Change OMNIMATE® Power BLZ 7.62HP

1. General Overview

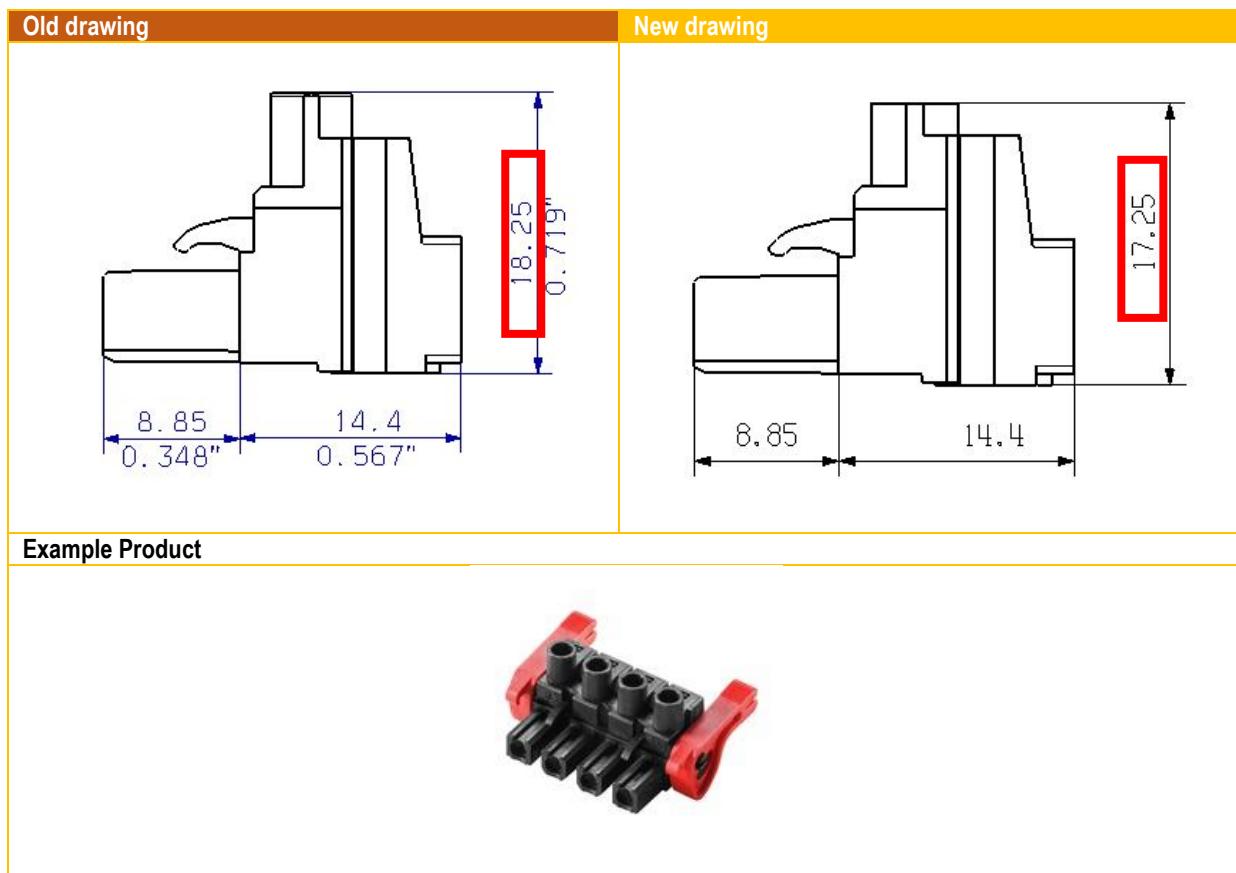
Due to optimization of the total connector height, we are going to reduce the red marked dimension by 1mm.

The required finger safe, clearance and creepage distances will be covered
